TECHNICAL BULLETIN

PREVENTATIVE MAINTENANCE - ACTION RECOMMENDED

SUBJECT: PNP ADAPTER FOR LIGHT CURTAIN RECEIVER.

EQUIPMENT: PEELLE CAR DOOR LIGHT CURTAIN REVERSING DEVICE (PEELLE PART

RD RELAY EXISTING WIRING RD RELAY NEW WIRING

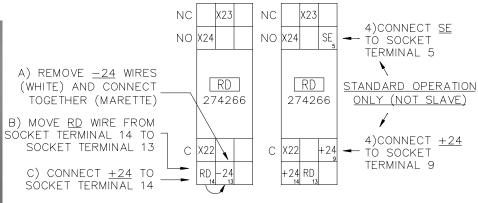
3) REWIRE THE RD RELAY INSIDE THE DOOR CONTROLLER:

A) REMOVE THE <u>-24</u> WIRES FROM SOCKET TERMINAL 13 AND CONNECT TOGETHER (MARETTE).

B) REMOVE <u>RD</u> WIRE FROM SOCKET TERMINAL 14 AND CONNECT TO SOCKET TERMINAL 13.

C) ADD WIRE FROM TERMINAL <u>+24</u> TO SOCKET TERMINAL 14.
